April 12, 2023

MGP Files: 19-2816

**RE: Copper Creek Community, Block 55 NW, City of Vaughan
Re-location of Park 'C' to buffer Humberplex residents**

Figure 1: Comparison of Park Options

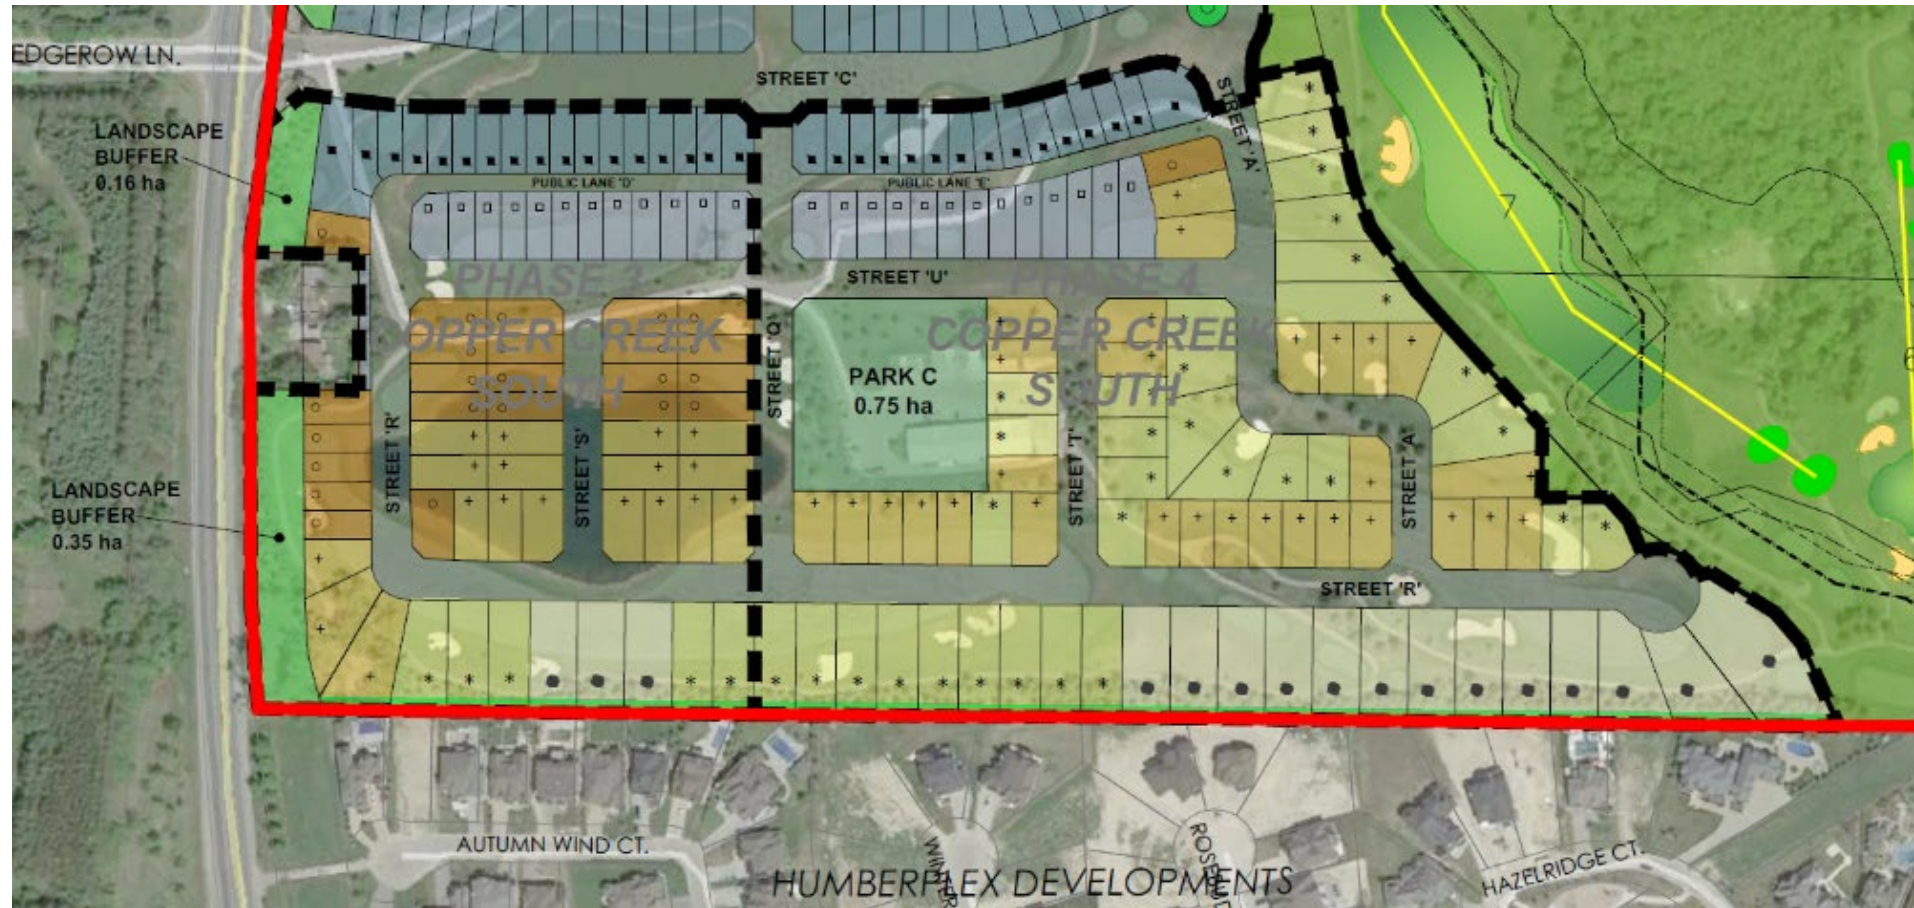
We have looked at replacing Park C with housing and adding a linear park along the southern limit of the Copper Creek Community. I have the following comments on the linear park proposal:

- The linear park will not provide amenity or play areas for the new residents.
- The elimination of Park C removes a 0.75 ha (1.8 acre) active play / open grass area from the future residents south of collector road – Street C on the Block Plan.

- The removal of Park C would result in the lower section of the block being outside of a walking distance of 400m radius from a public neighbourhood park.

- Most of the linear park will be hidden behind lots, which could present security issues for adjacent existing and future residents and does not meet the principles of Crime Prevention Through Environmental Design (CPTED). The CPTED principles include natural surveillance to create a safe and secure environment that encourages activity, vitality and viability.

- The 10m linear park width is not sufficient to protect the existing vegetation, as many of the trees will need to be removed to make room for the trail. As the trees are conifers, they can't be pruned the same as deciduous trees to allow for trails to wind between the trunks under the canopy. This reduces the effectiveness and use of the linear park to preserve the vegetation and to provide a visual buffer from new development.

- A trail system within the 10m park width will result in trails being 3 to 4m from the rear lot lines on each side which is inconsistent with Vaughan's preference for 10m between trails and lot lines.

- The linear park has limited access points: Hwy 27, one from the future subdivision road and one through the southern portion of the golf course.
- The elimination of the centrally located Park C reduces the sustainability score by 6 points, lowering it from a Silver to a Bronze score. This is itself is not good planning or community building, nor does it support the sustainability objectives of the City.

BLOCK 55 NORTHWEST - BLOCK PLAN

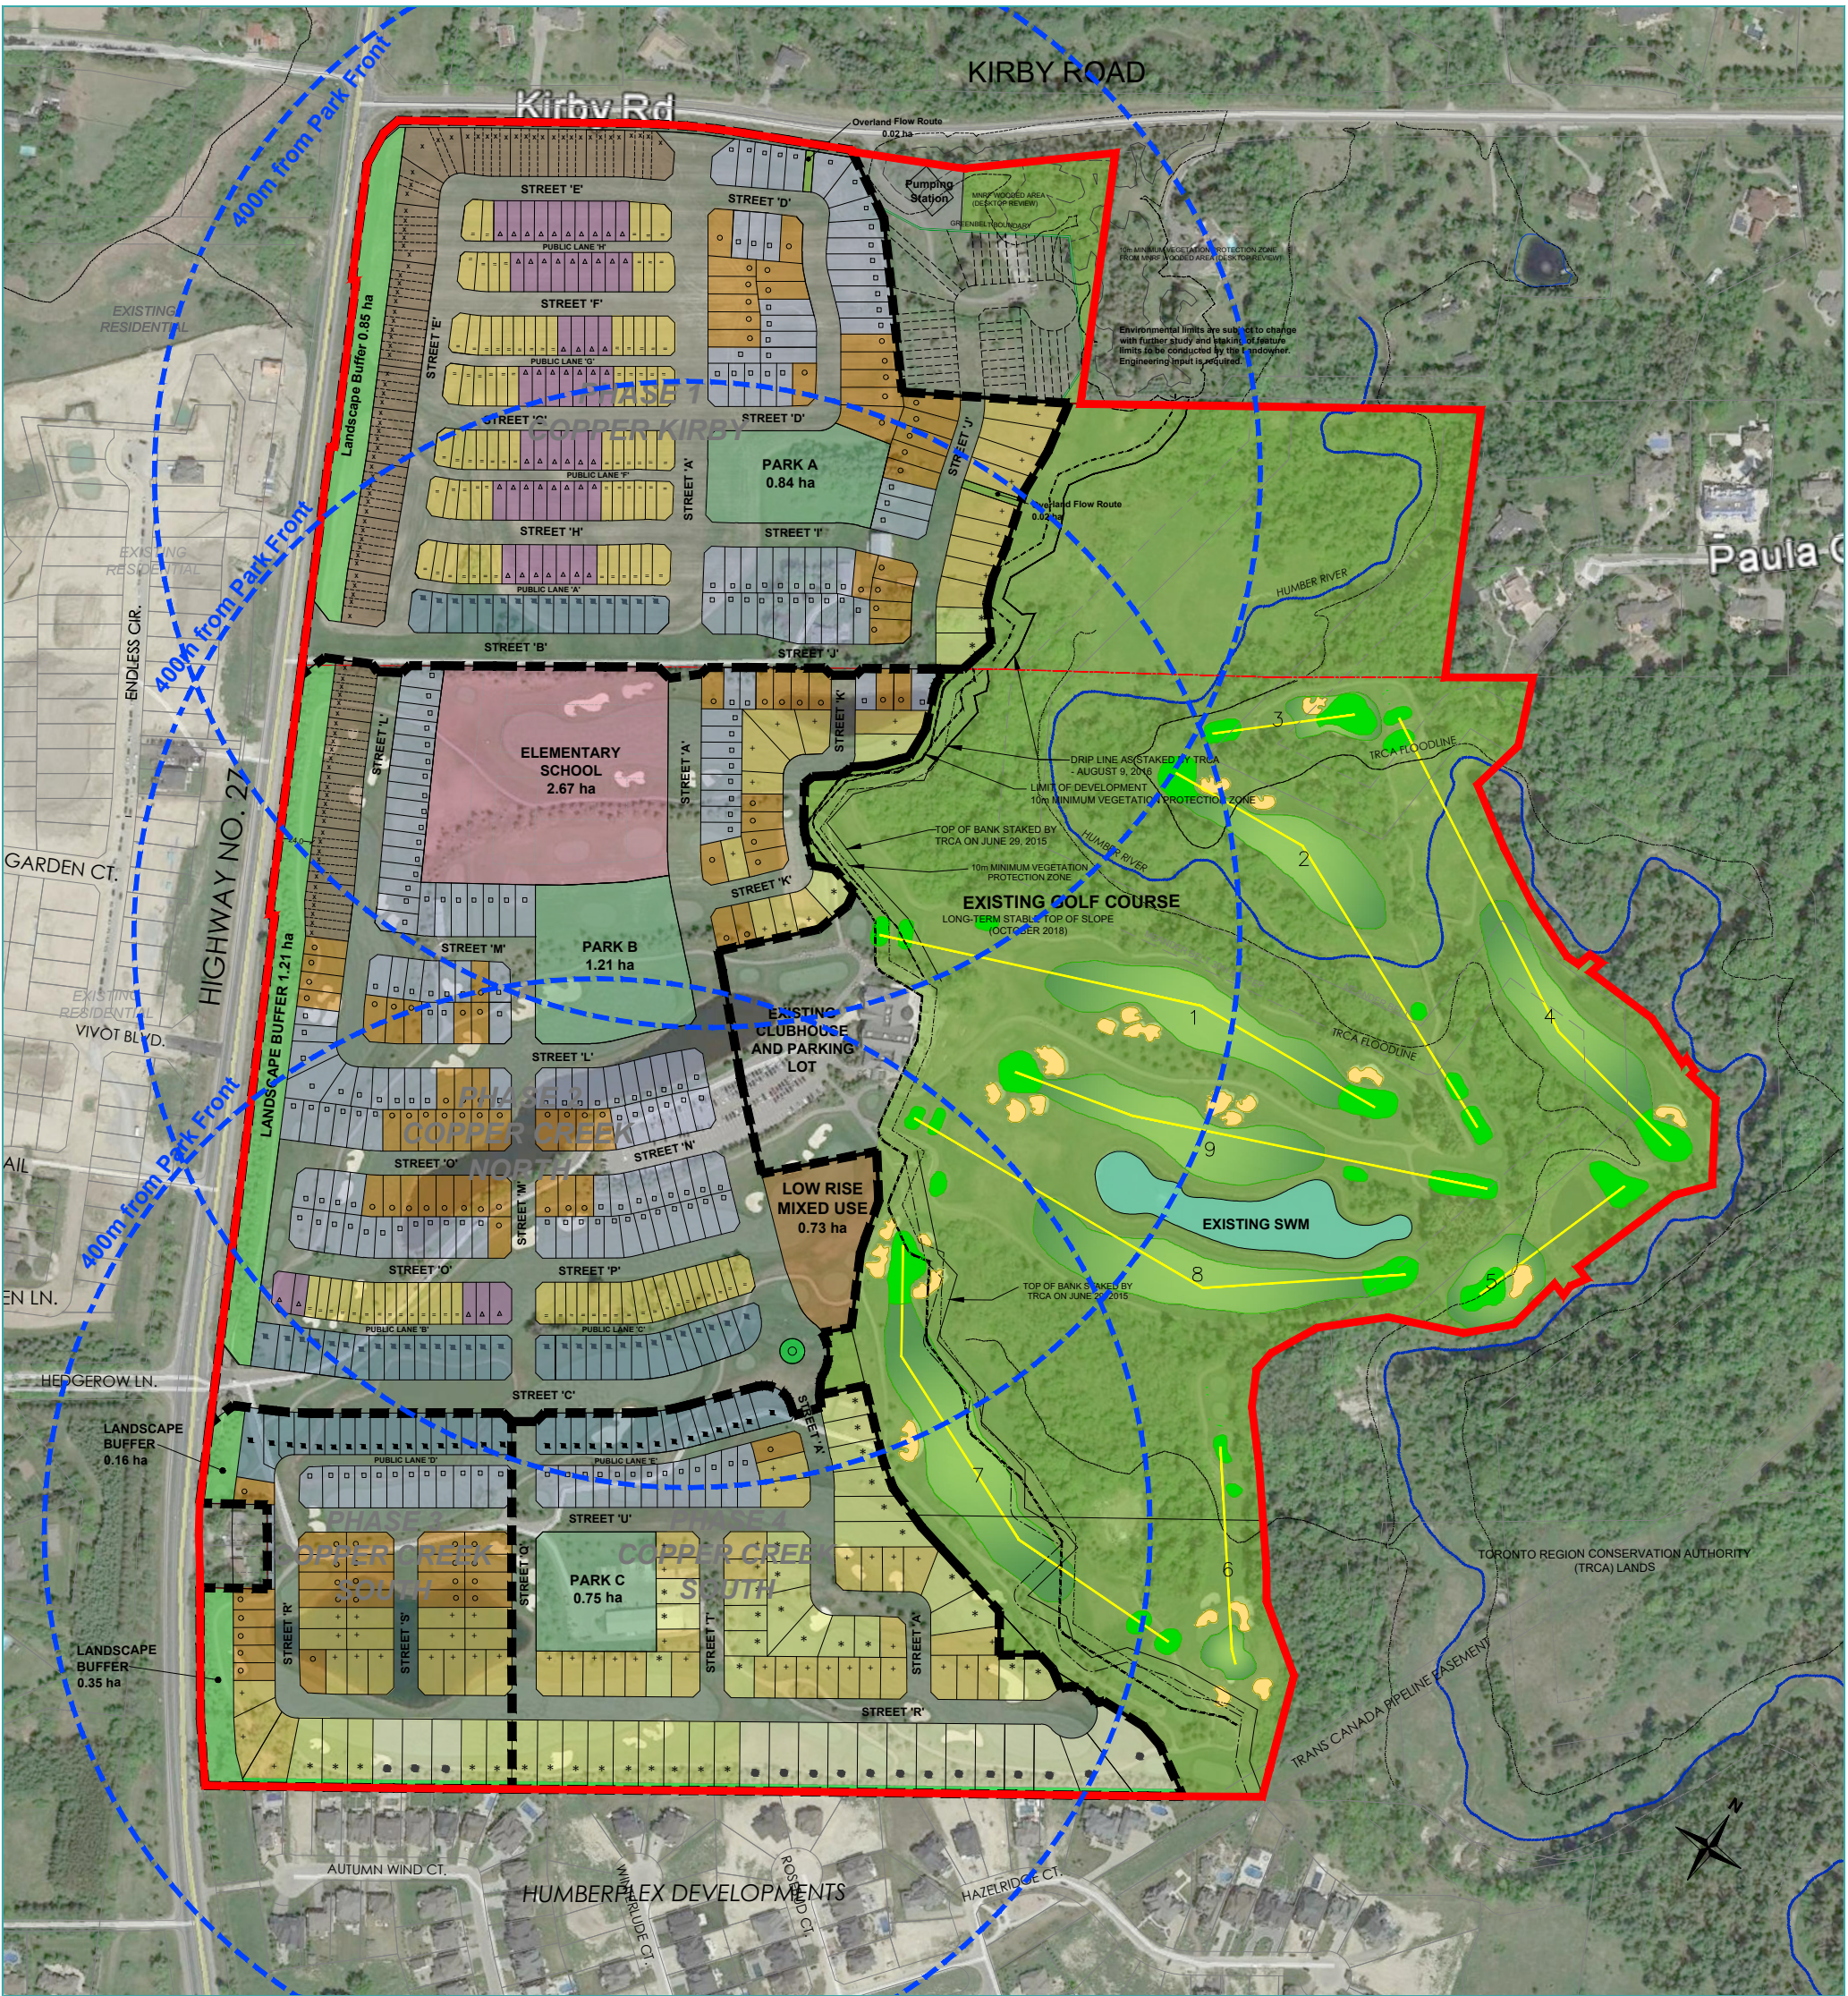
Park C – From Revised Draft Plan shown at March 16, 2023 meeting.

BLOCK 55 NORTHWEST - BLOCK PLAN

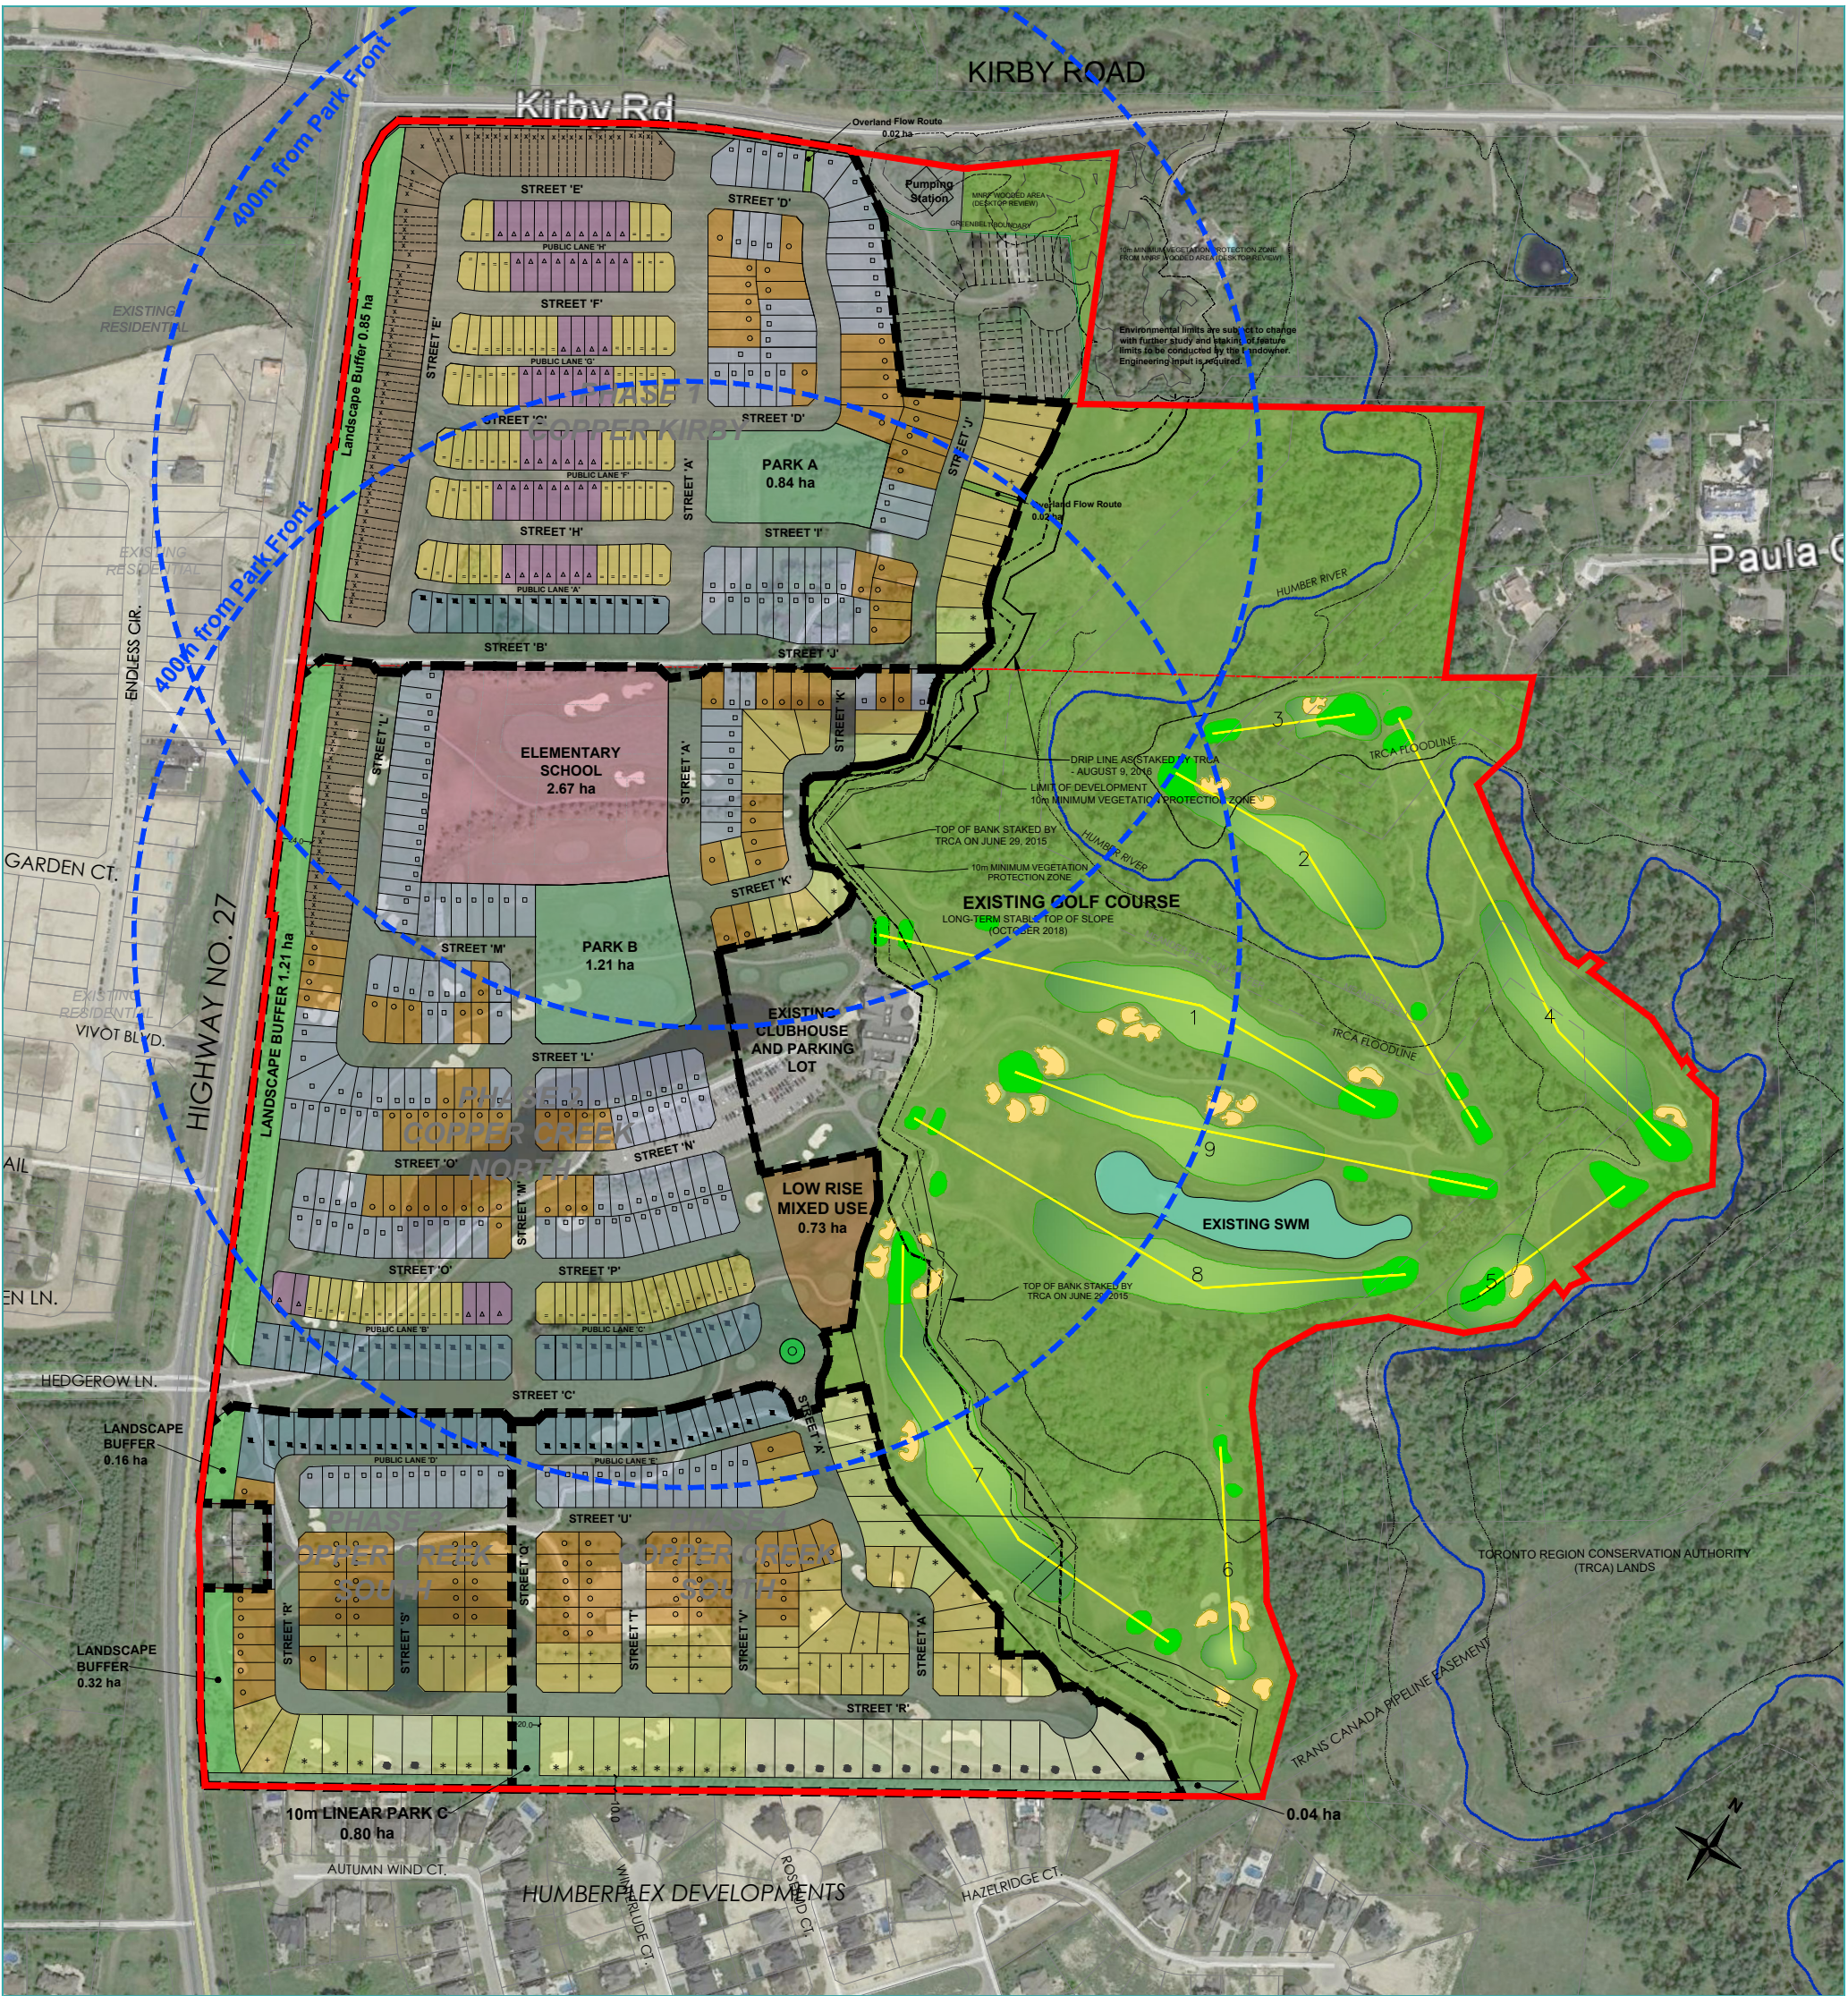
Park C – Relocated South to Humberplex Boundary
